Final Product/Process Change Notification

Document #:FPCN23931Y

Title of Change:	Change of assembly and test site, lead frame design and mold compound for MicroFC-30020 and MicroFC-30050	
Proposed First Ship date:	19 Aug 2021 or earlier if approved by customer	
Contact Information:	Contact your local ON Semiconductor Sales Office or Deborah.Herbert@onsemi.com	
PCN Samples Contact:	Contact your local ON Semiconductor Sales Office or PCN.samples@onsemi.com . Sample requests are to be submitted no later than 30 days from the date of first notification, Initial PCN or Final PCN, for this change. Samples delivery timing will be subject to request date, sample quantity and special customer packing/label requirements.	
Additional Reliability Data:	Contact your local ON Semiconductor Sales Office or Ricky.Garcia@onsemi.com	
Type of Notification:	This is a Final Product/Process Change Notification (FPCN) sent to customers. FPCNs are issued 90 days prior to implementation of the change. ON Semiconductor will consider this change accepted, unless an inquiry is made in writing within 30 days of delivery of this notice. To do so, contact PCN.Support@onsemi.com

**BEFORE****AFTER**

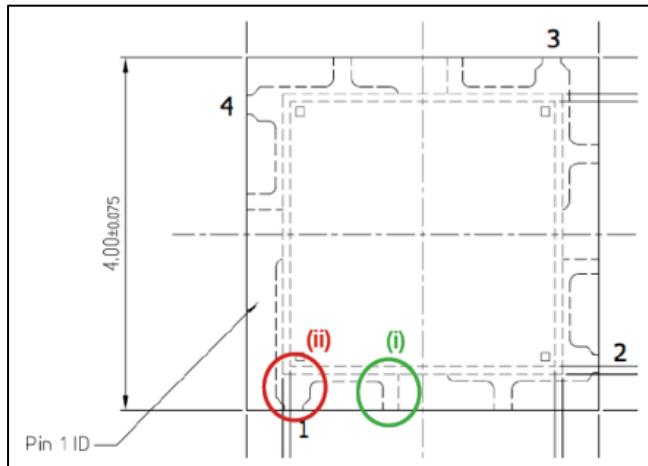
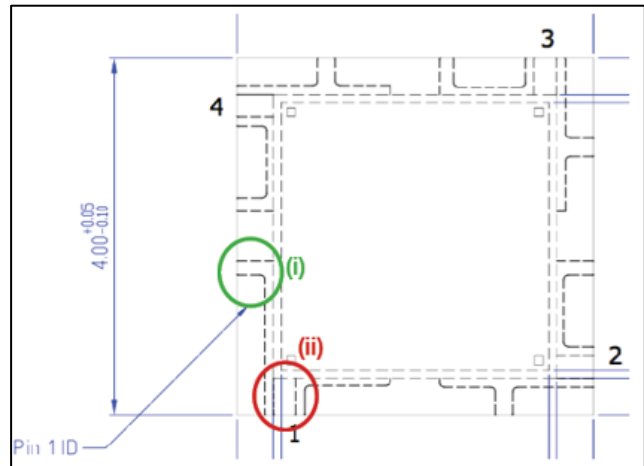
(i) The half-etch tab on pin 1 is relocated - the half etch tabs do not contact the base of the package as there is package material underneath so there is no change to the package footprint and the recommended solder footprint has not changed.

(ii) The pull in etch of the solder pads 1 - 4 at the edge of the package have been changed to a flat edge. There is no change to the recommended solder footprint.
